**PLANNING DEPARTMENT ADMINISTRATIVE PUBLIC HEARING
SUMMIT COUNTY, UTAH
December 19, 2024**

Subject: 2900 Deer Valley Drive
Application: PL-24-06344
Author: Virgil Lund, Planner II
Date: December 19, 2024
Type of Item: Administrative Conditional Use Permit

Subject: 8909 Moonshadow Court, Unit G
Application: PL-24-06343
Author: Virgil Lund, Planner II
Date: December 19, 2024
Type of Item: Administrative Conditional Use Permit

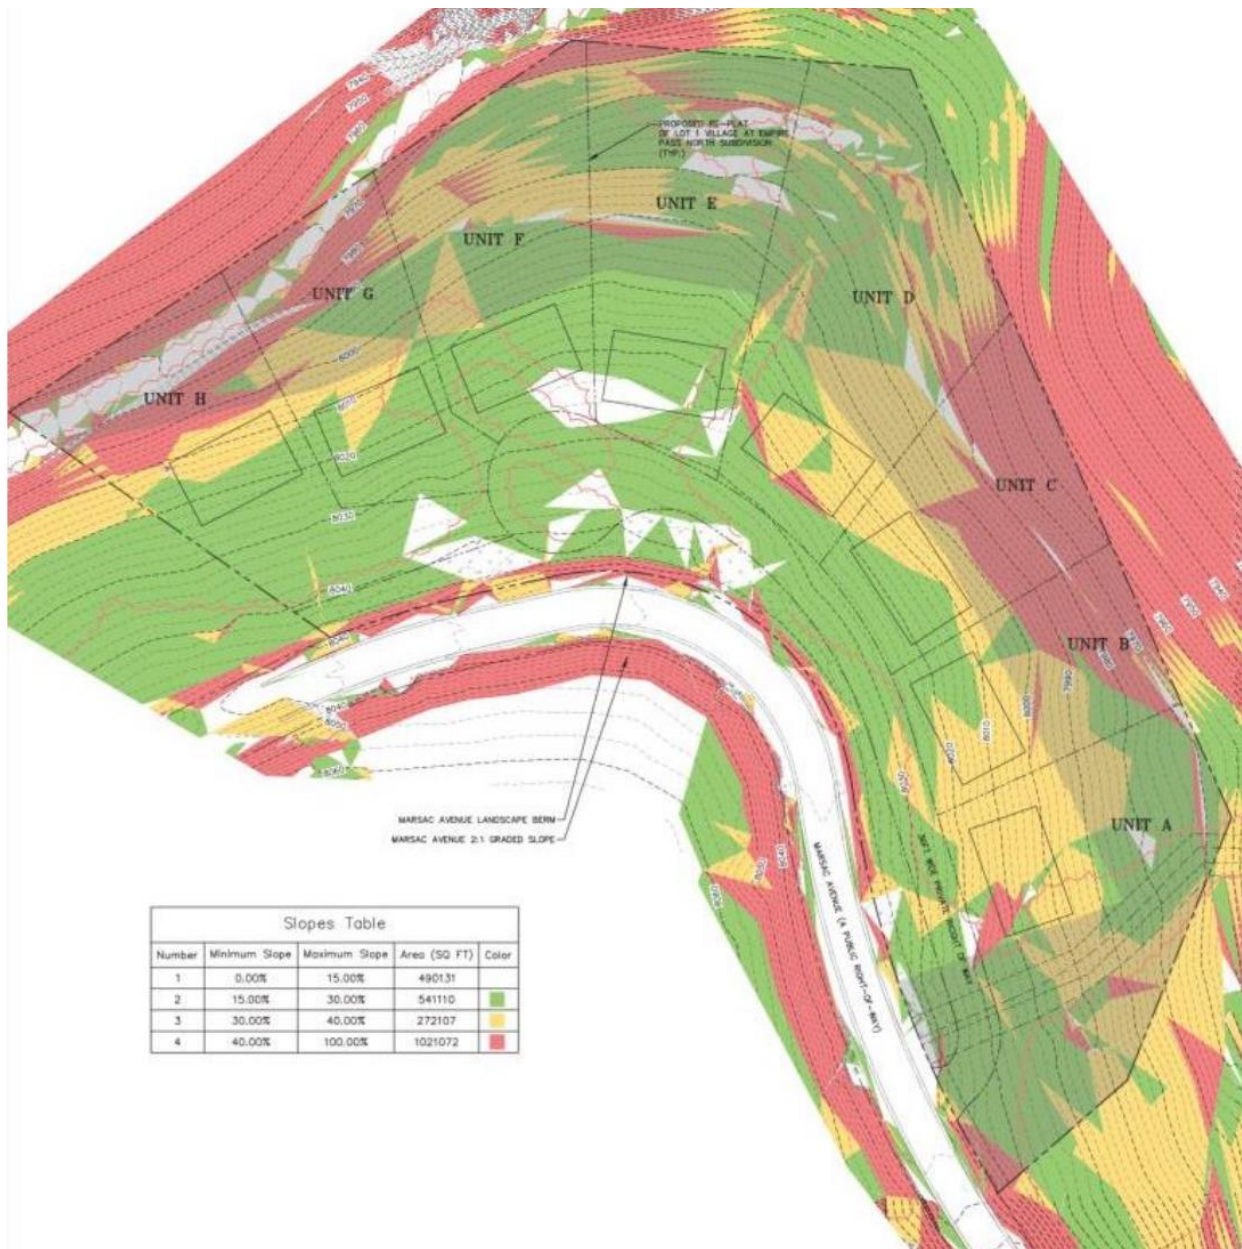
SLO Analysis Criteria	Analysis of Proposal
Slope/Topographic Map: A Slope and topographic map based on a certified boundary survey depicting contours at an interval of five feet (5') or less. The map must highlight Areas of high geological hazard, Areas subject to land sliding, and all significant Steep Slopes in categories of greater than 15%, 30-40%, and greater than 40%.	Complies The SLO Technical reports (Exhibit J) from 2018 were reviewed and approved by the Planning Commission and City Council as part of the original Subdivision and Plat approval. Road and Building development will not occur on slopes greater than 40%. Majority of Slopes greater than 30% will remain as Open Space. Minor development to occur on Slopes between 30% and 40%. The image below, taken from the 2018 technical reports, shows the Slope percentages for each Unit.

Exhibit I includes a vegetation map from the 2018 technical reports. It is included below for quick reference.

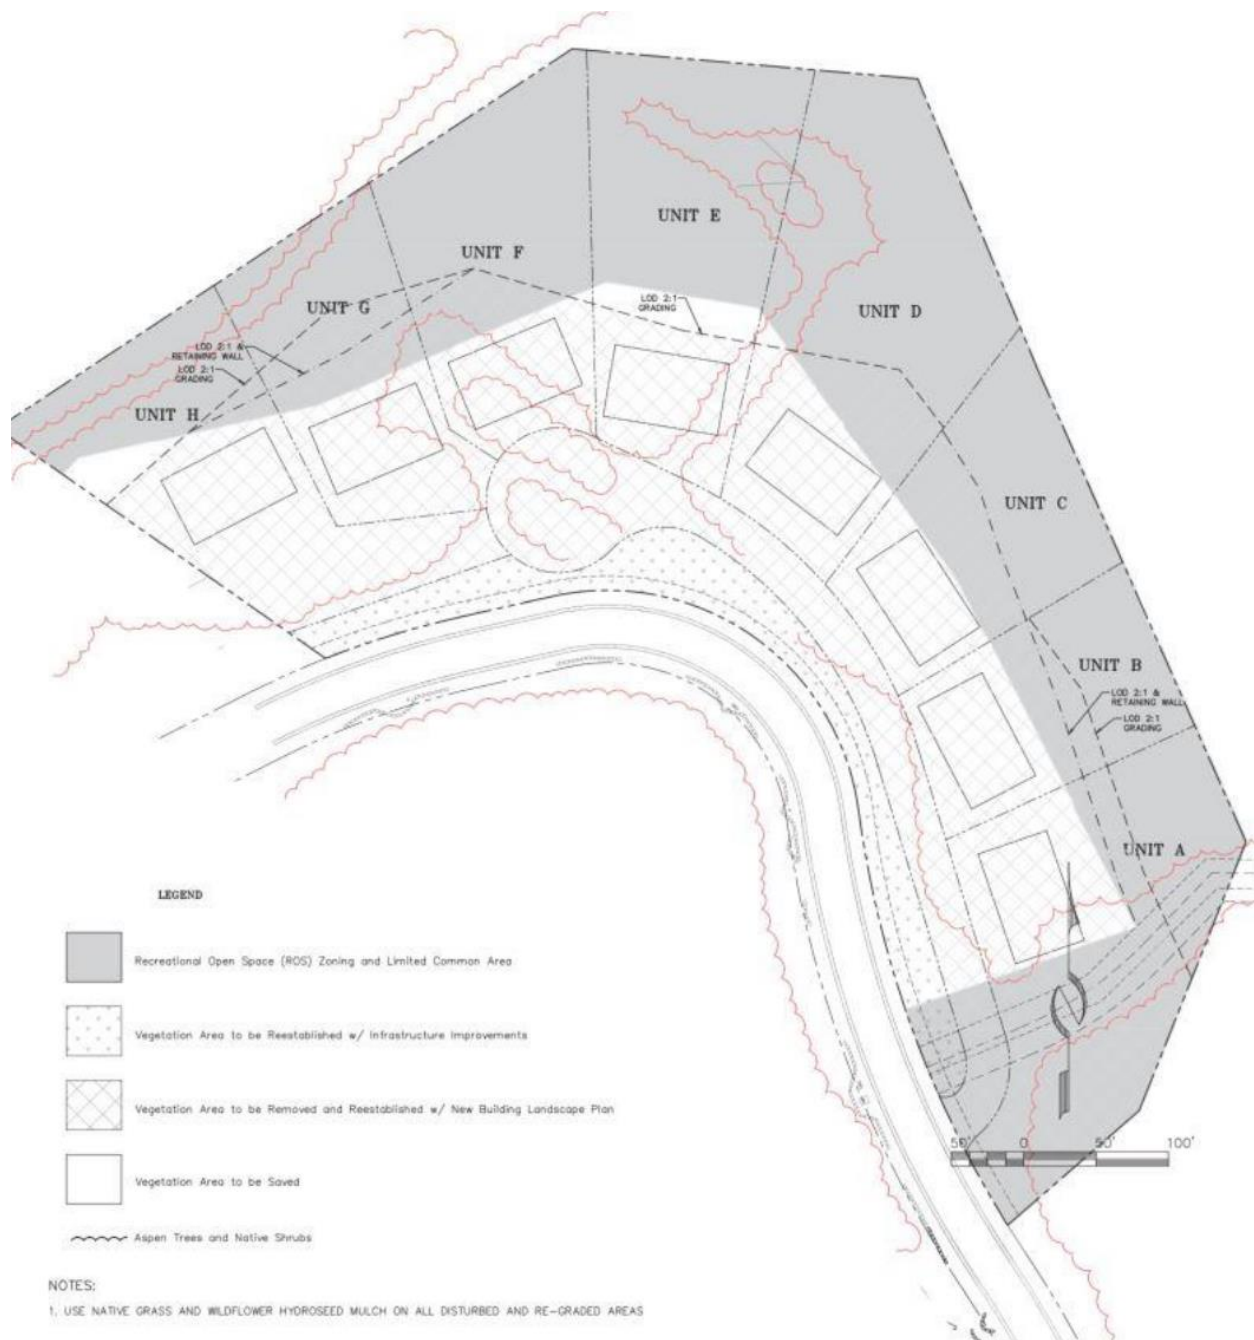
Vegetative Cover: a detailed map of vegetative cover.

Complies
